# TEXTIL FASHIONS LTD.

Holding no6/1, Plot -168, Soydana, Gazipur

4<sup>th</sup> November, 2015

# Observations

# Stress Level at Columns

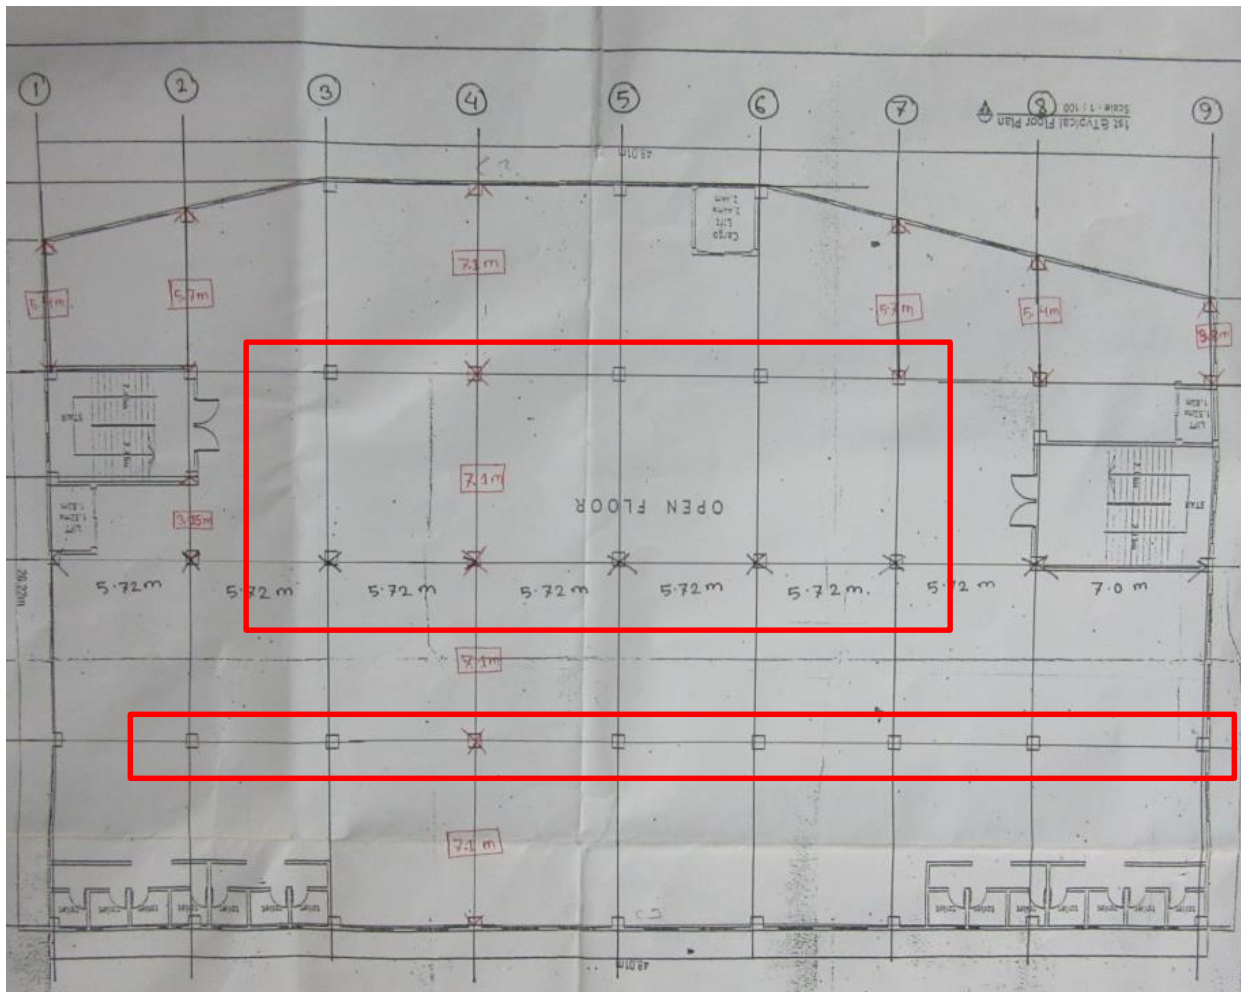
Marked columns are found to have high stresses considering the full build-out stage of the construction (8-storey building).

| Item No. | Observation                                            | Recommended Action Plan                                                                                                                                                                                                          | Recommended Timeline |
|----------|--------------------------------------------------------|----------------------------------------------------------------------------------------------------------------------------------------------------------------------------------------------------------------------------------|----------------------|
| 1        | Stress Level at Columns in full build-out              | Stress level at most of the columns found to be high in the case of an 8-storey building.                                                                                                                                        | 6-weeks              |
| 2        | Stress Level at Columns in full build-out              | Building Engineer to check design according to the actual state of column types and dimensions before proceeding with the construction of upper floors. Consideration should be given to reducing the number of proposed floors. | 6-weeks              |
| 3        | Stress Level at Columns in full build-out              | Make structural alterations if required as advised by Engineer.                                                                                                                                                                  | 6-months             |

Structural Drawing

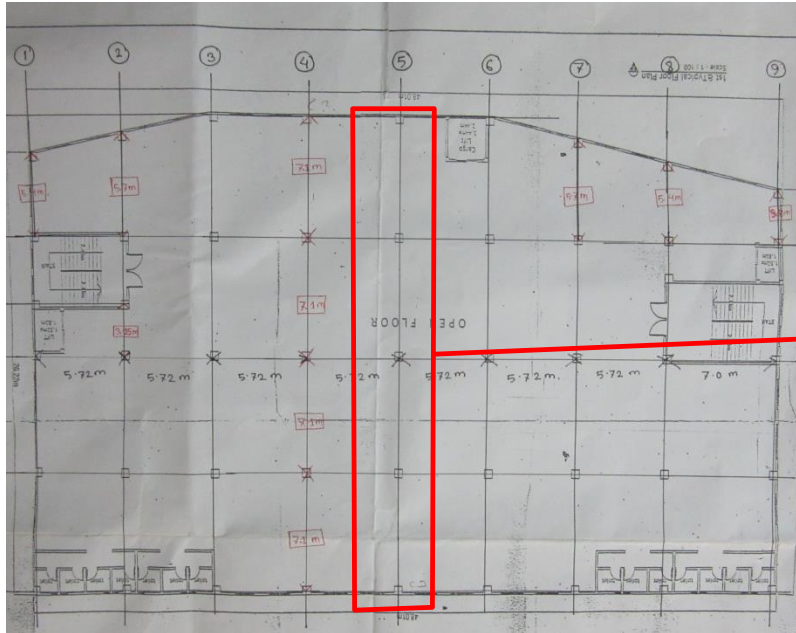
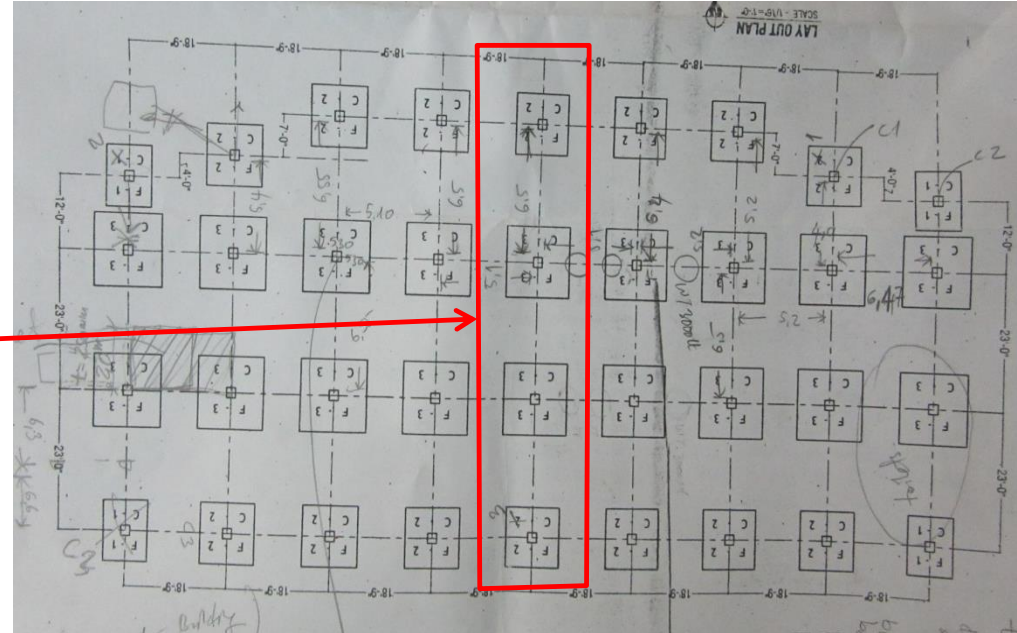
Structural drawing shows 4 columns in north–south direction instead of 5 columns which is observed at site and as shown on the architectural drawing.

| Item No. | Observation                                            | Recommended Action Plan                                                                                                                                                                                                          | Recommended Timeline |
|----------|--------------------------------------------------------|----------------------------------------------------------------------------------------------------------------------------------------------------------------------------------------------------------------------------------|----------------------|
| 7        | Discrepancies between Design Drawings and Observations | Building Engineer to update the structural design drawings to reflect the as-built structure.                                                                                                                                    | 6-weeks              |
| 8        | Discrepancies between Design Drawings and Observations | Make structural alterations if required as advised by Engineer.                                                                                                                                                                  | 6-months             |

Provided Structural Drawing

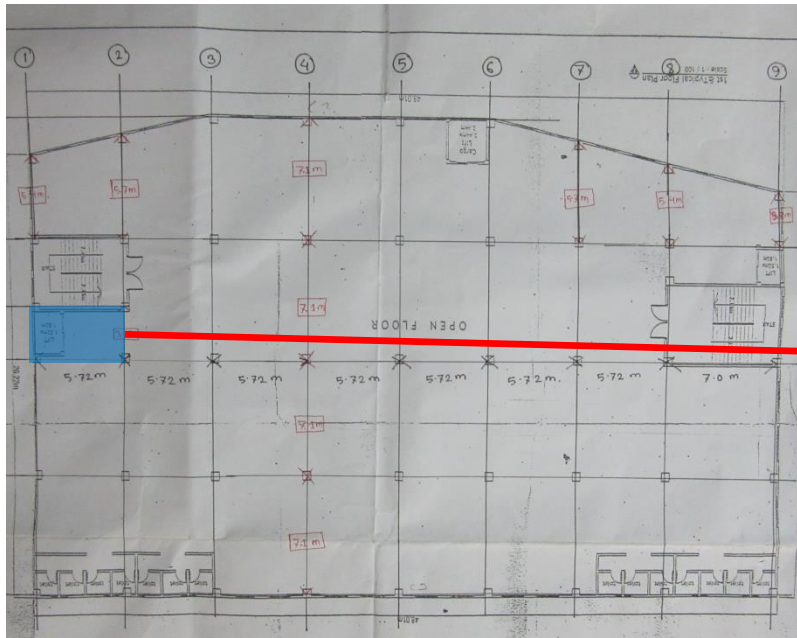
There is a toilet area at the west side of the 1<sup>st</sup> floor which is not shown in permission drawing.

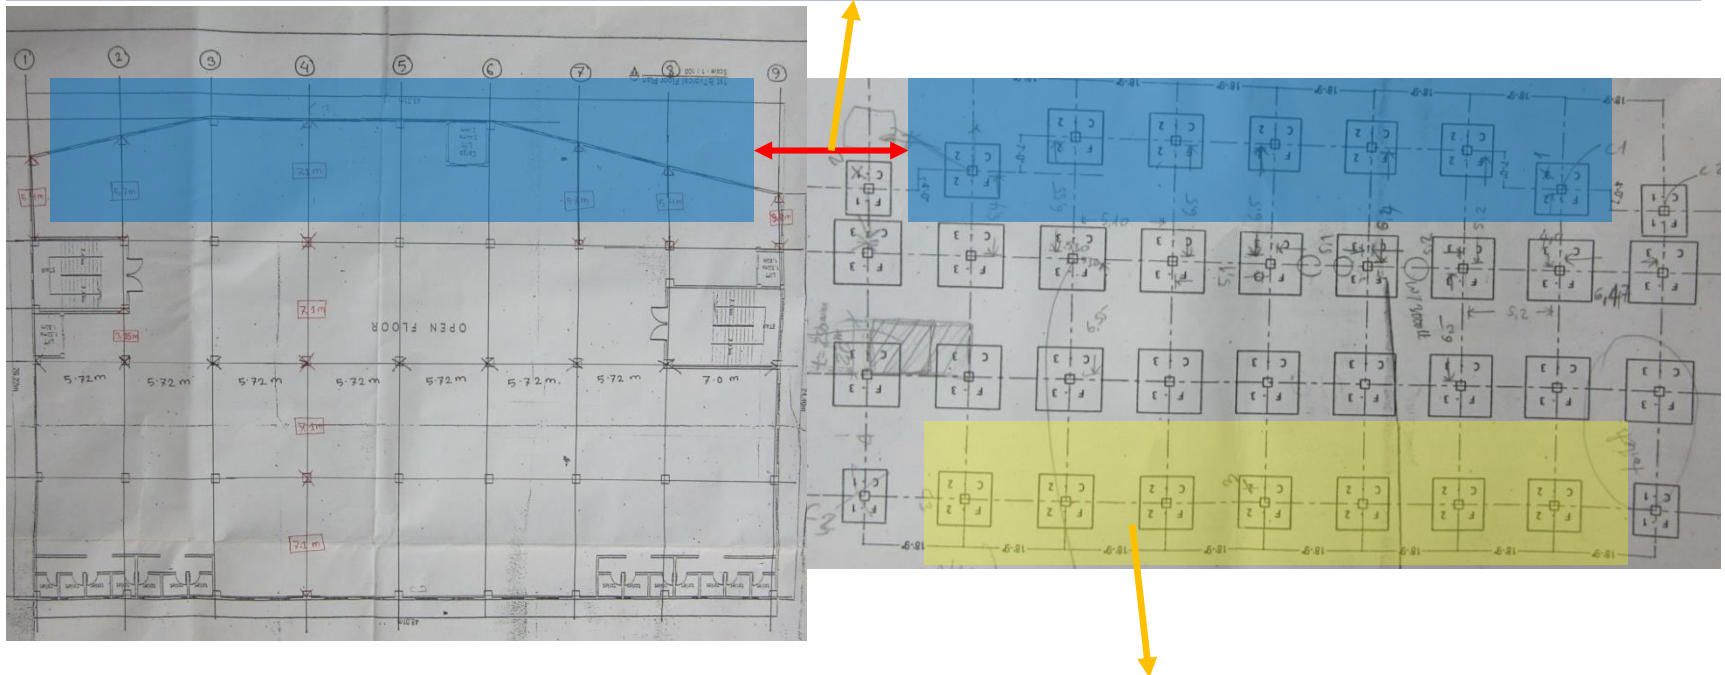
The dimensions of C2 Columns observed at roof level are smaller than what is shown on the structural drawings.

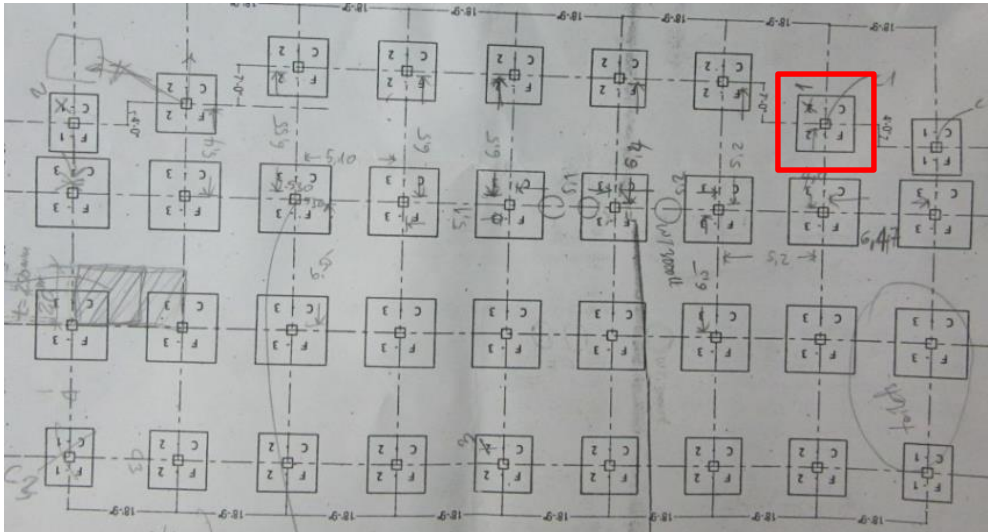
C2 type columns are only found at North edge where as the drawings shows the South edge columns also as C2.

Only one C1 type column was found in the whole building.

We found additional columns around staircases which were not present in any drawings.
